## SB, Motor Change, PRIME DM and PC, 2020-09

### SYMPTOM/DESCRIPTION

Figure 1: Cover kit in red circle

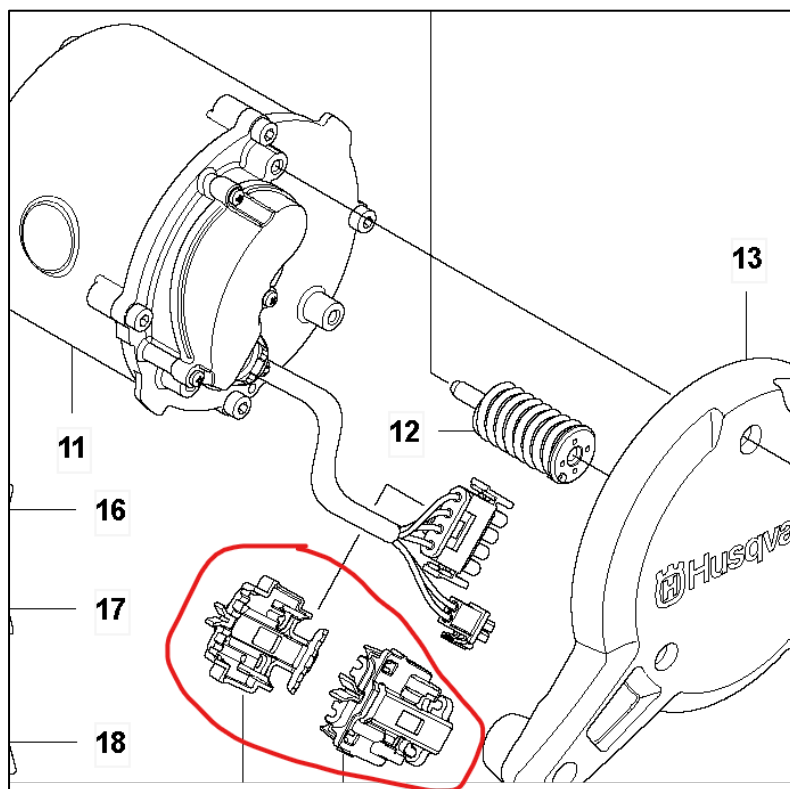
The motor cables in newly introduced K7000 and DM700 are a little thicker. To compensate for thicker cables a COVER KIT (figure 1) is included with each motor.
